**DEPARTMENT OF TRANSPORTATION
STATE OF GEORGIA**

Richmond County
GDOT District 2 - Tonnille
TIA: SR 104 @ I-20

SUBJECT APPROVED CONCEPT REPORT

S.R. 104/RIVERWATCH PKWY @ I-20
CITY OF AUGUSTA
RICHMOND COUNTY
PI # 0011699

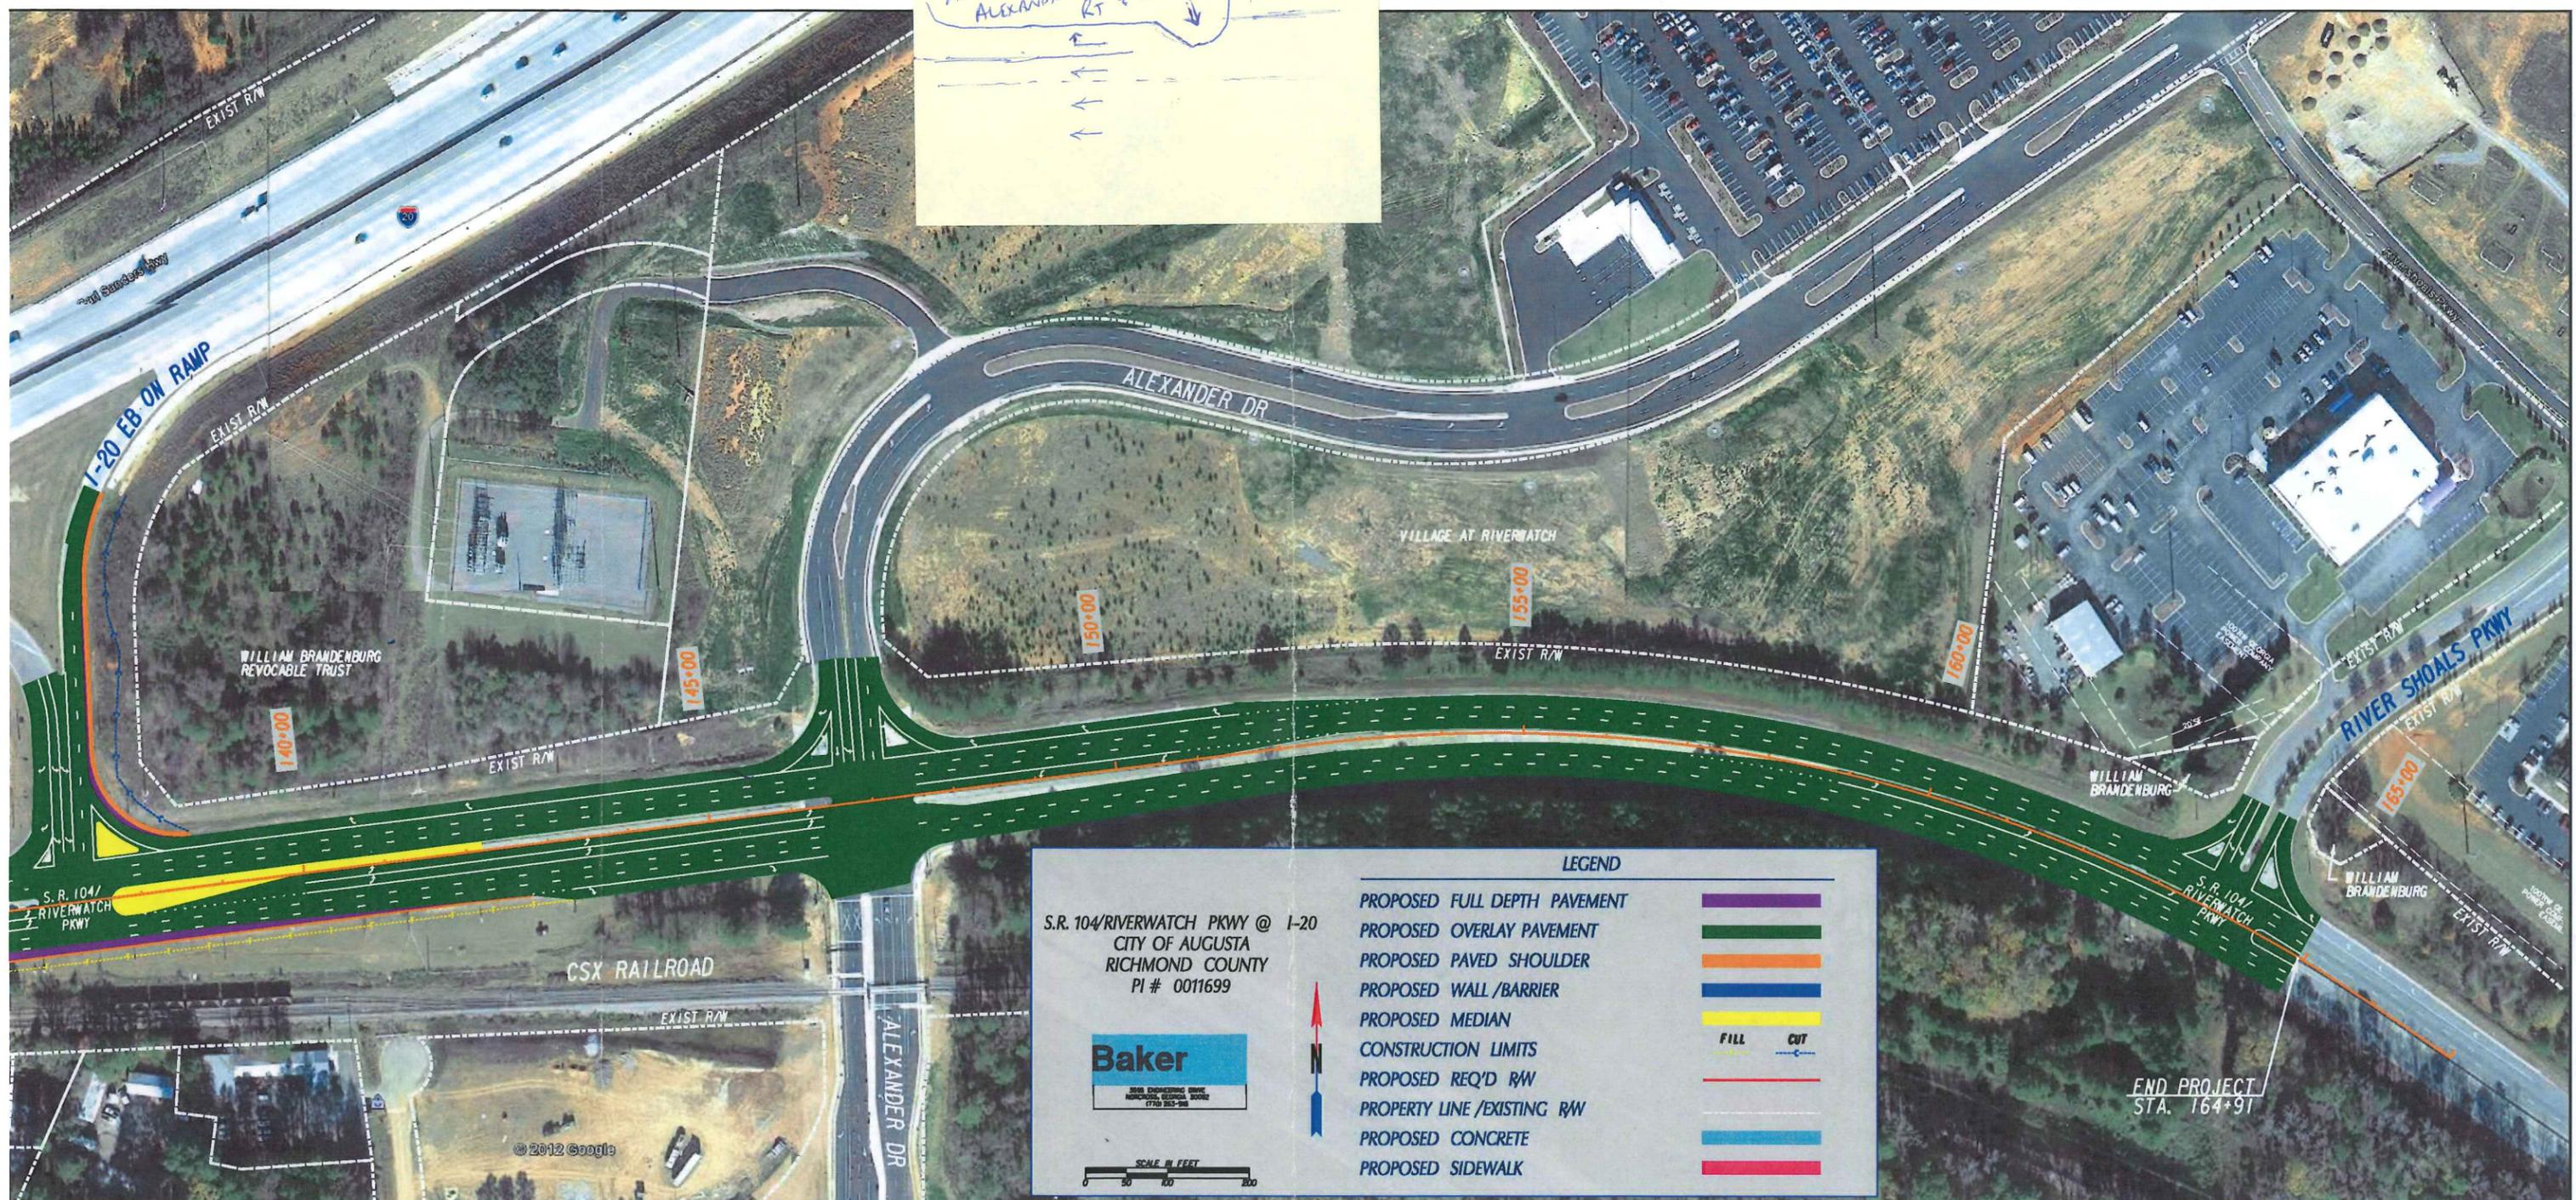
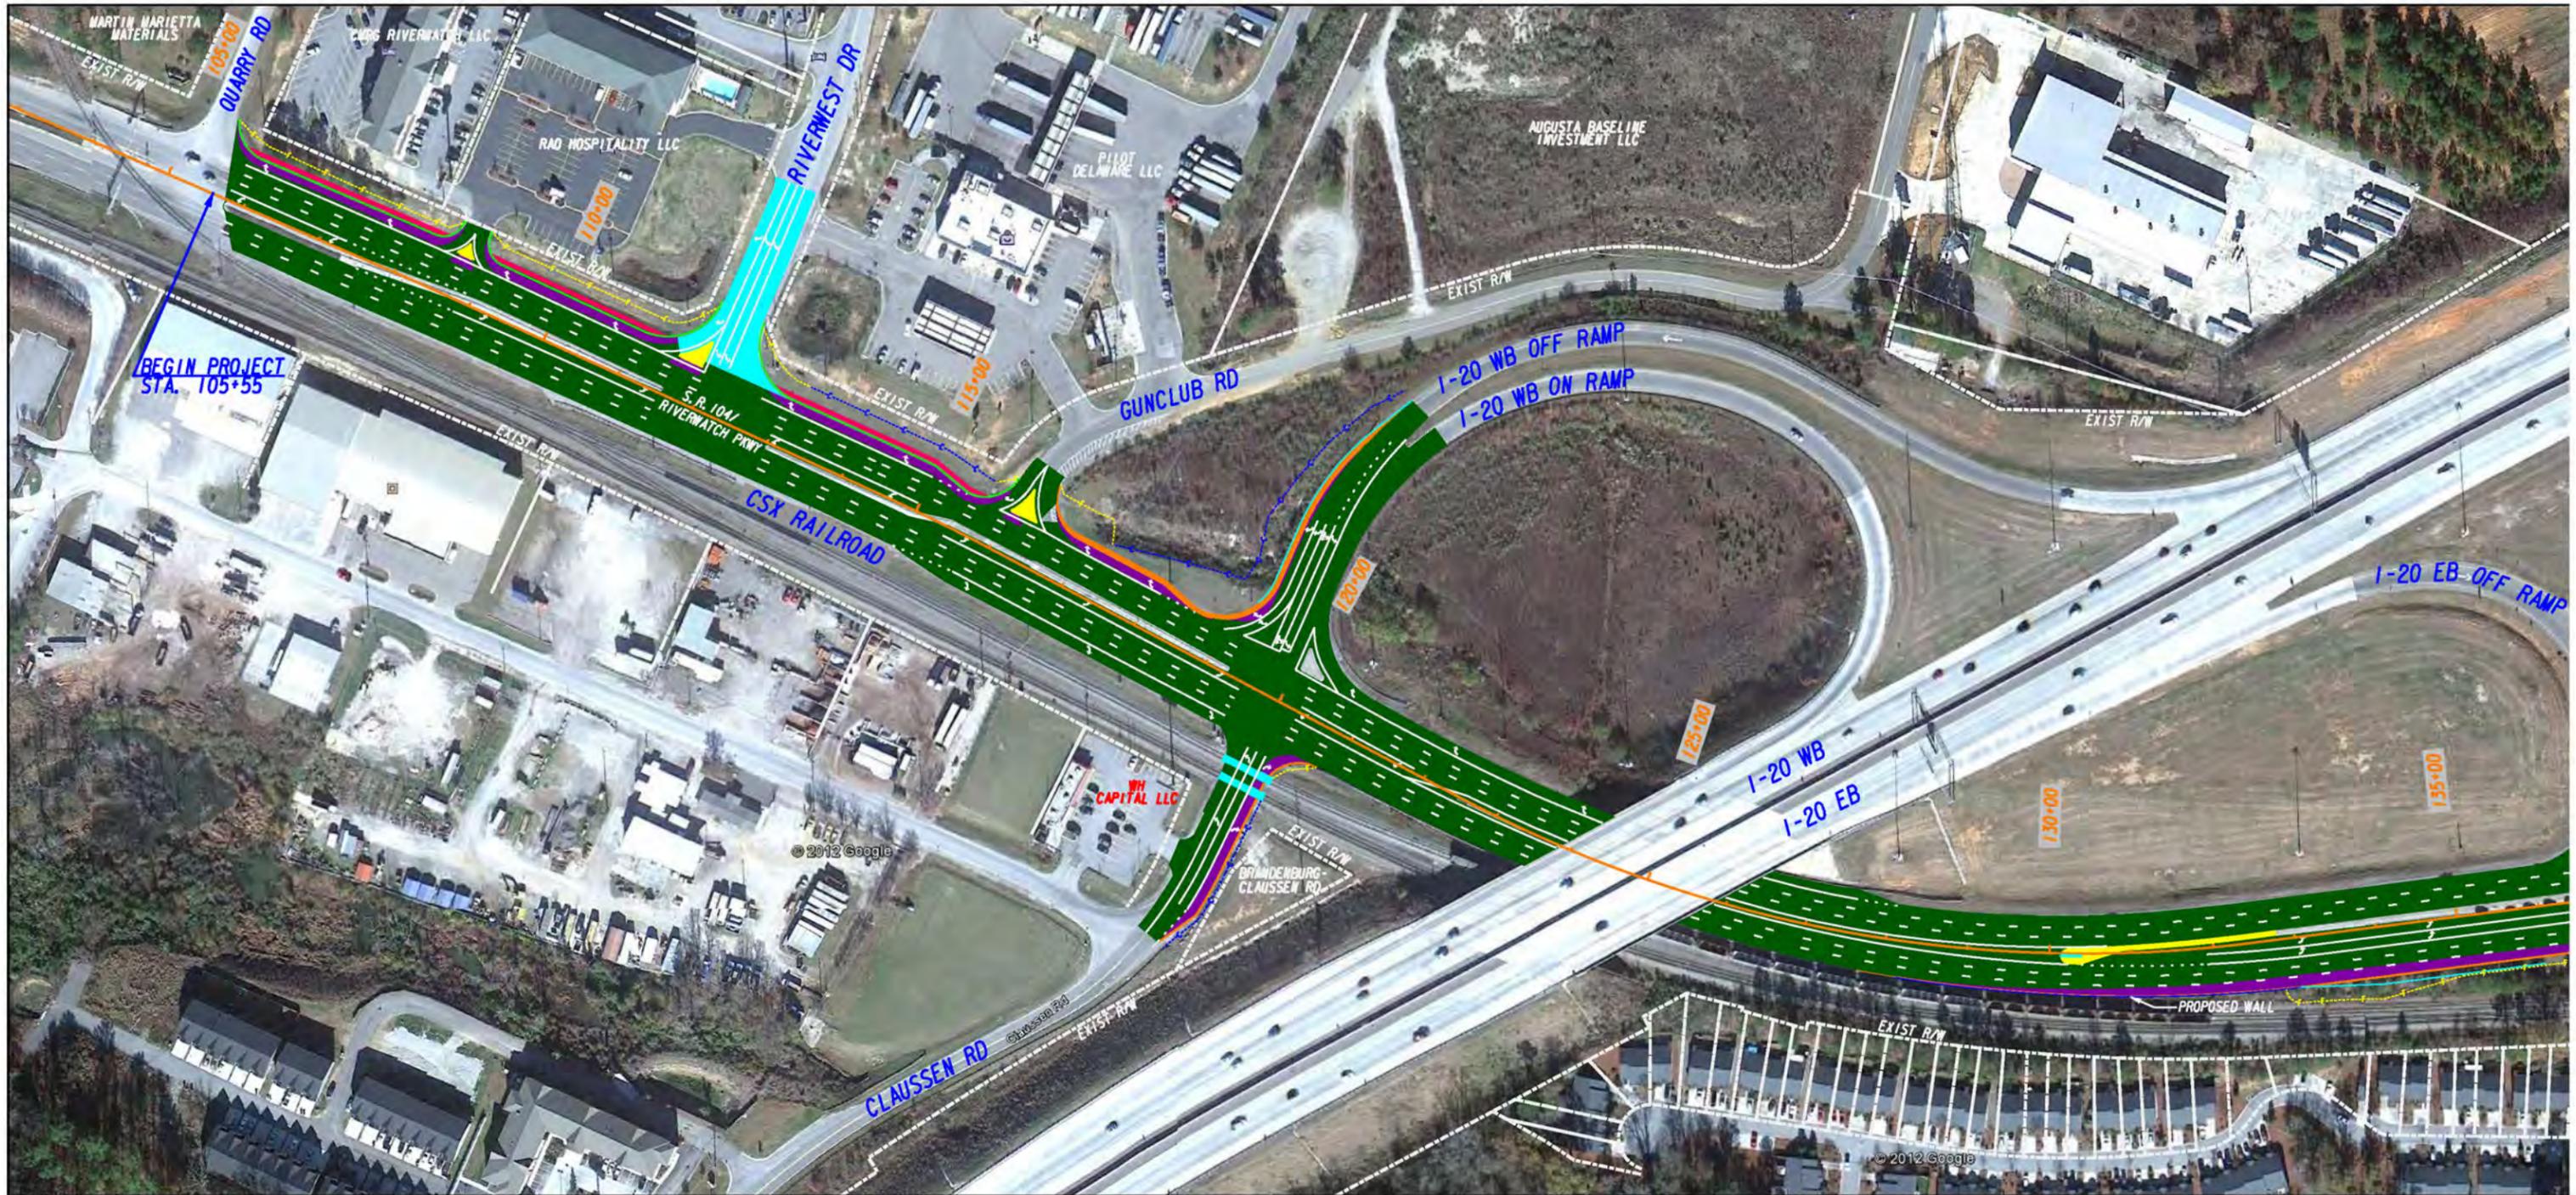
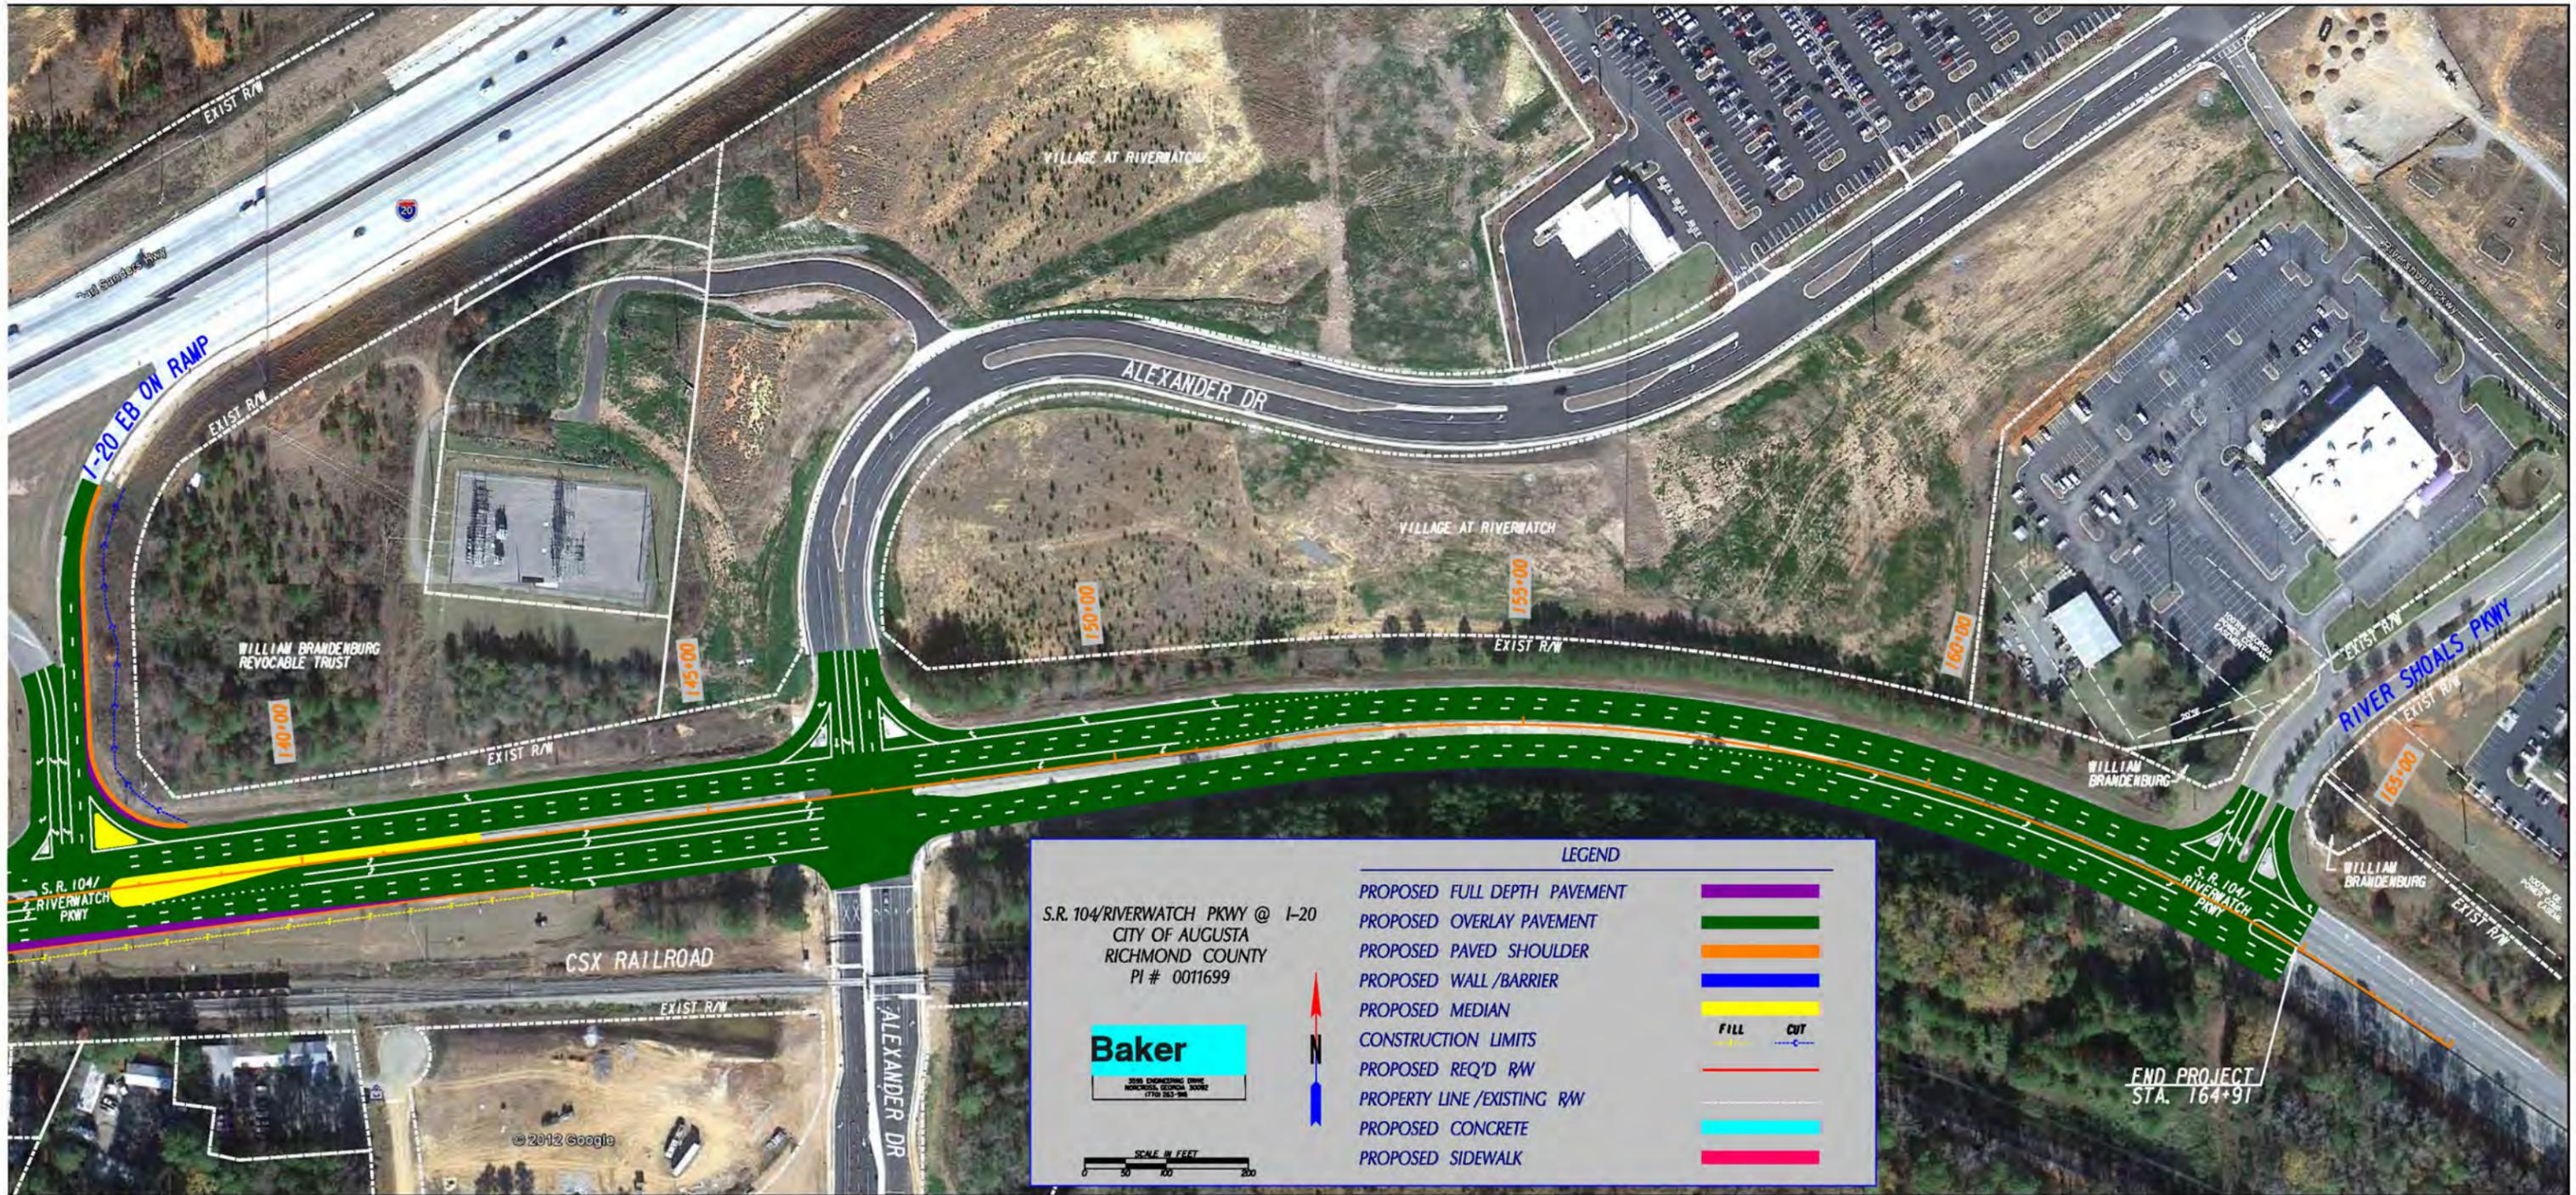
DESIGN REFINEMENT
ACCEL LANES TOO SHORT. SHOULD BRING RT. TURN INTO MAINLINE RATHER THAN FREE FLOW LANES.
RIVERWEST DR

CHECK ACEL DISTANCE & WEAVE (PREFER RIGHT TURN INTO MAINLINE IN URBAN AREAS) ^{ALSO} WHY NOT FIX ALEXANDER W/ 2 THURS + RT & LT?
